Sheet No. C0.0

Project Title:
EAST TOWN CROSSING PHASE 1

Project No.
2230752
Issue Set & Date:
PERMIT SUBMITTAL
11/20/2023

ELEVATION VIEW

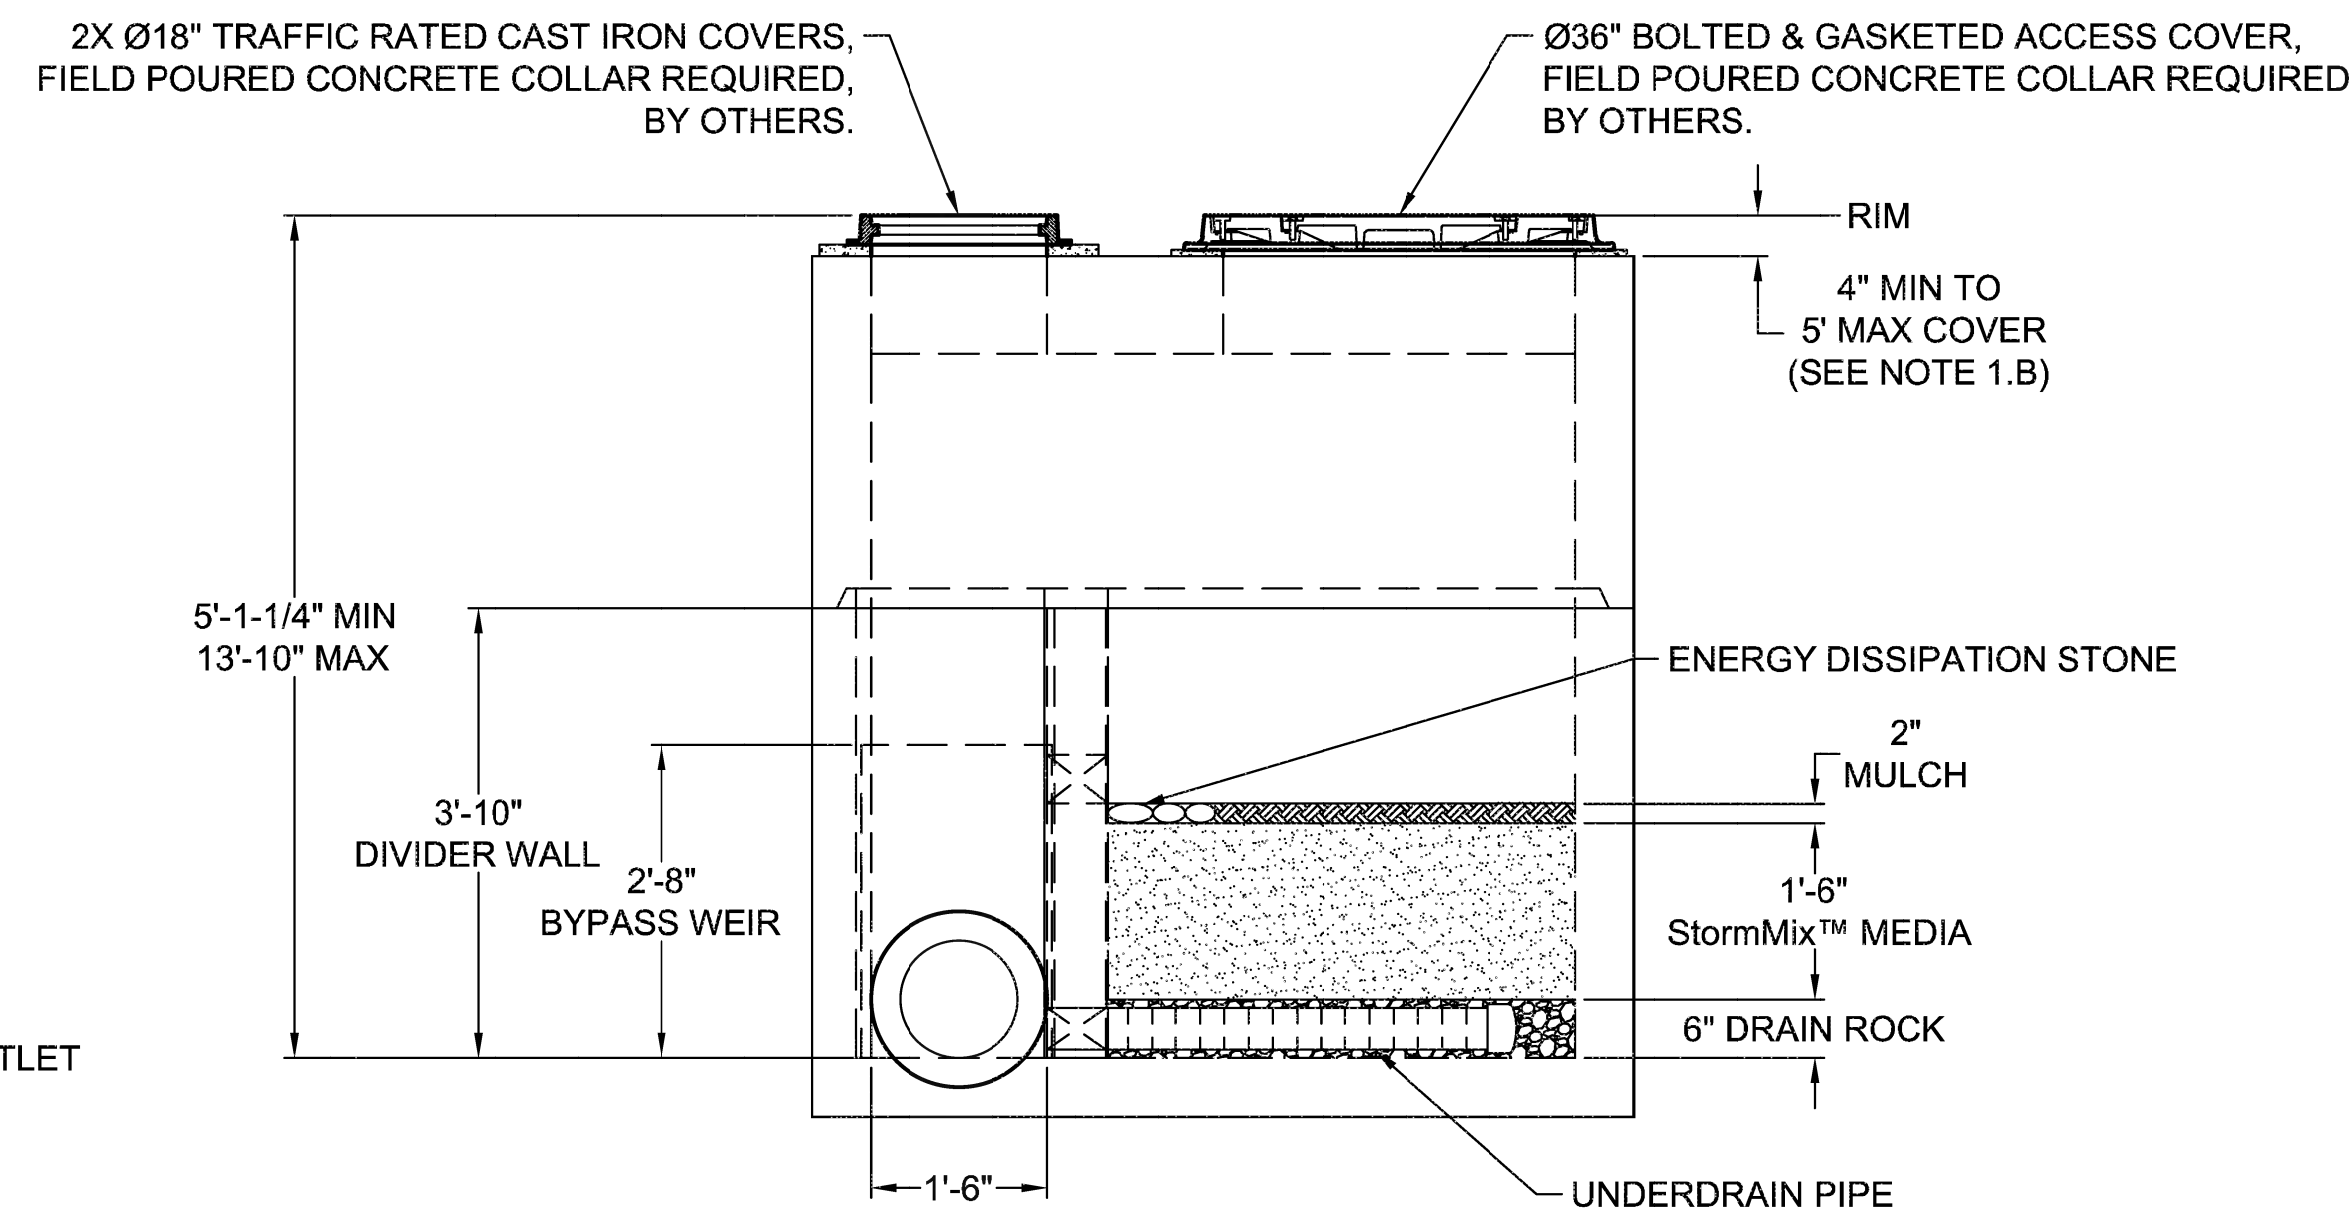
CLARIFY-whether the optional drain down device will be implemented. (See GULD Para 3) [Plans Sht C4.09, Pg 22 of 63]
Will not be included

Sheet No.
C4.11
24 of 63 Sheets

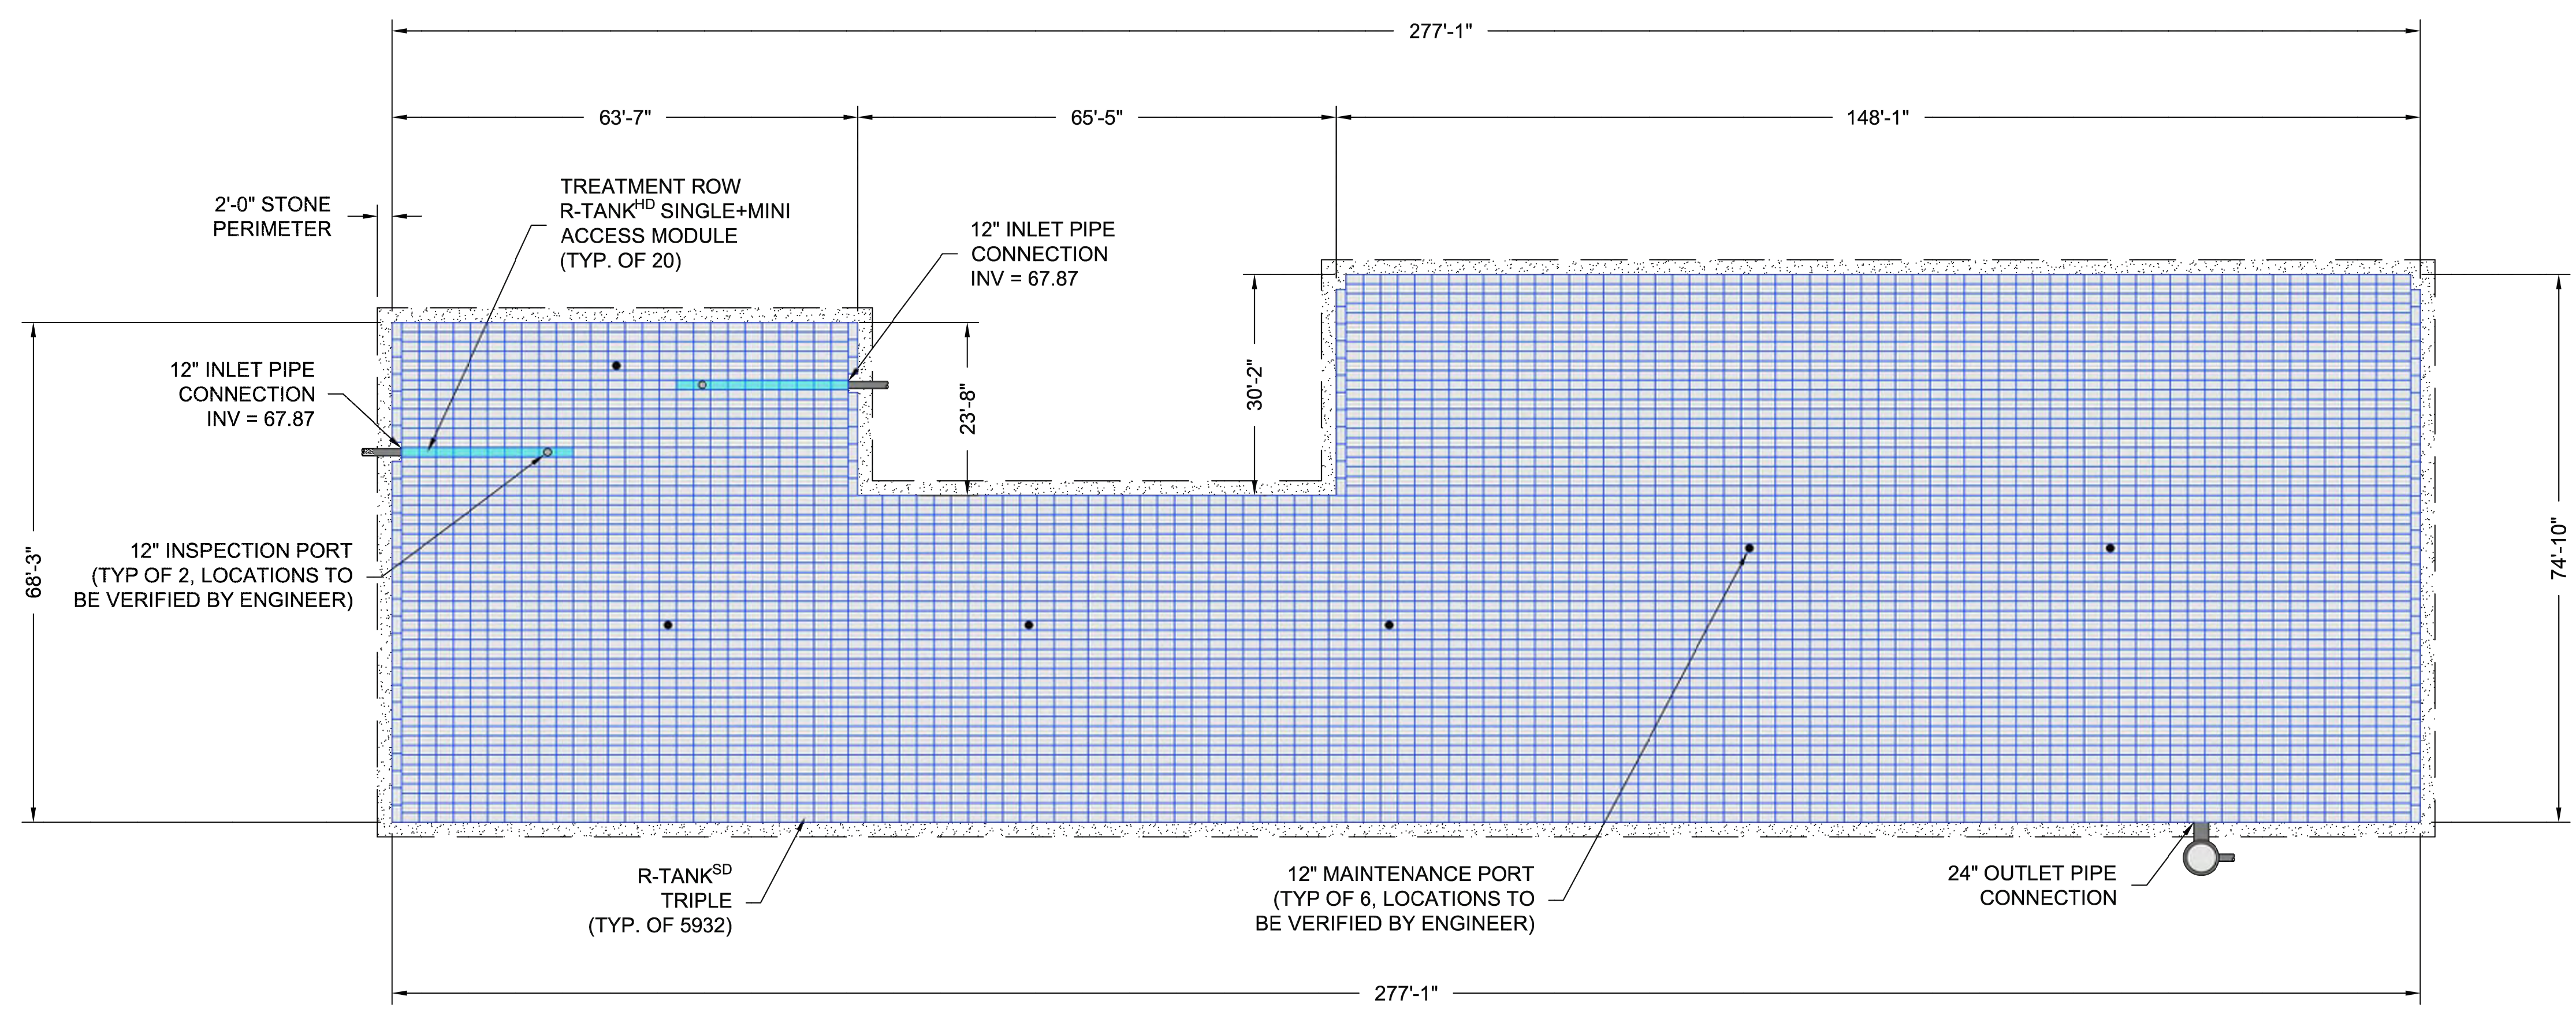
PROVIDE-2yr and 10yr water surface elevations on the cross section.
[Plans Sht C4.11; Pg 24 of 63]
Provided

R-TANK^{SD} SYSTEM LAYOUT
 EAST TOWN CROSSING
 PUYALLUP, WA
 SITE DESIGNATION: R-TANK 2

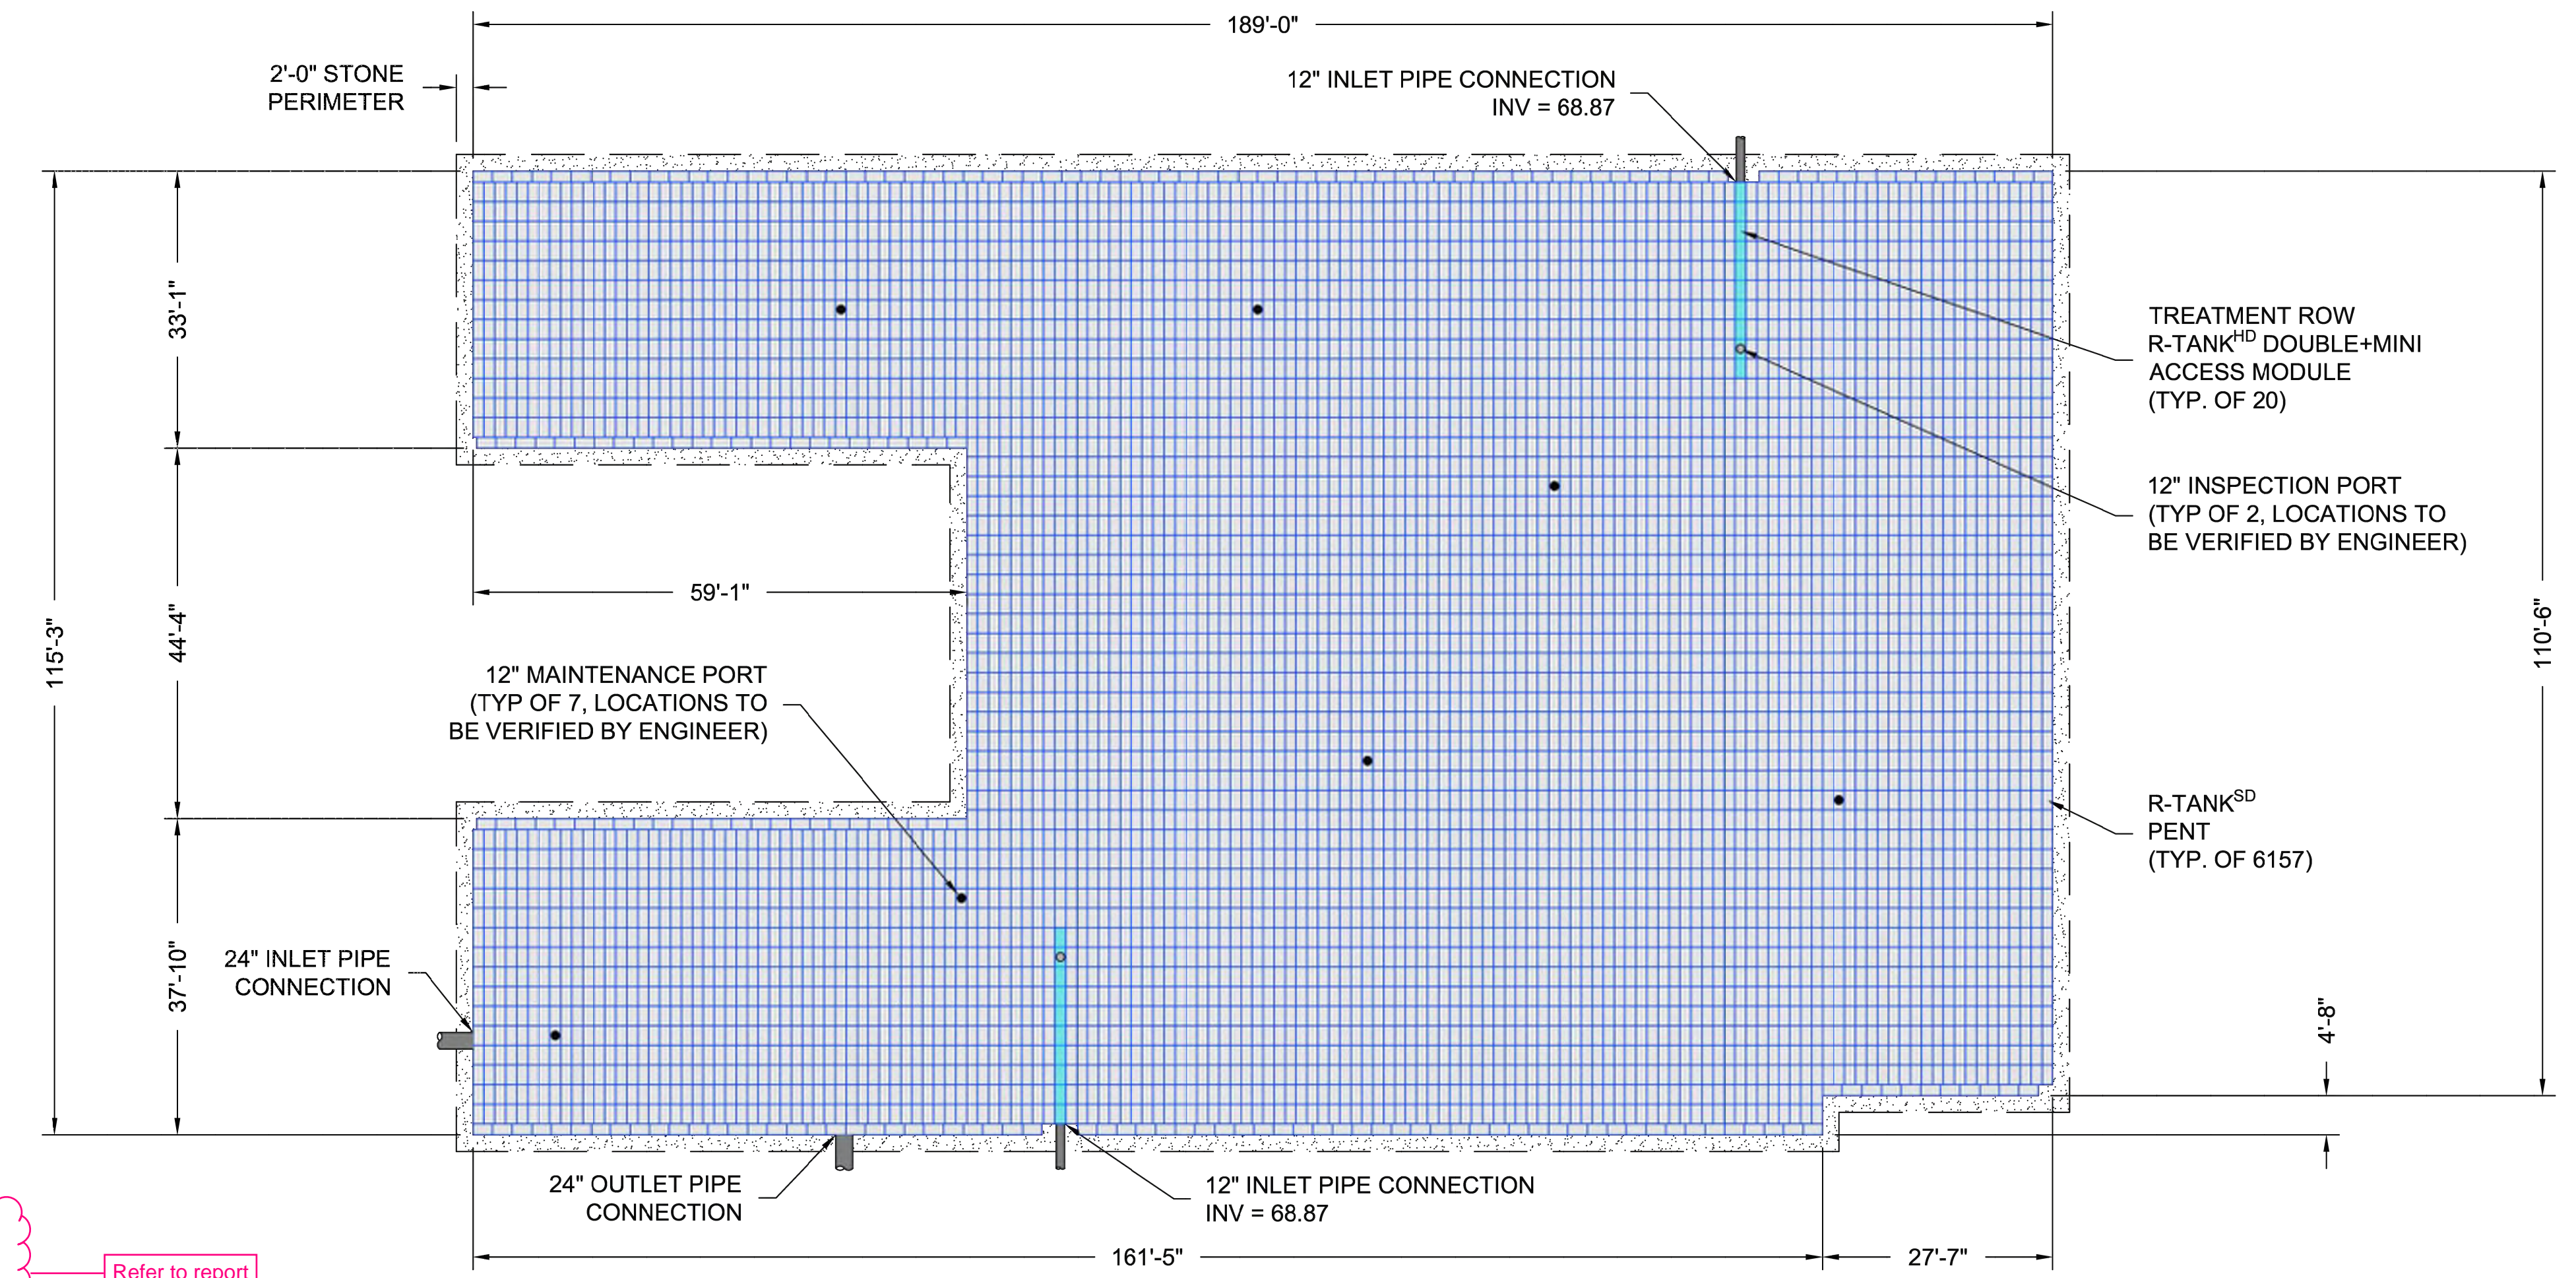
CLARIFY: See storage volume required comments in Storm Report, Pg 372 of 448. [Plans Sht C4.21; Pg 32 of 63] Refer to report

CLARIFY: See Control Structure comments on Sht C4.07, and riser comments in Storm Report, Pg 372 of 448. [Plans Sht C4.21; Pg 32 of 63] Refer to report

PROVIDE 2yr and 10yr water surface elevations on the cross section. [Plans Sht C4.21; Pg 32 of 63] Provided
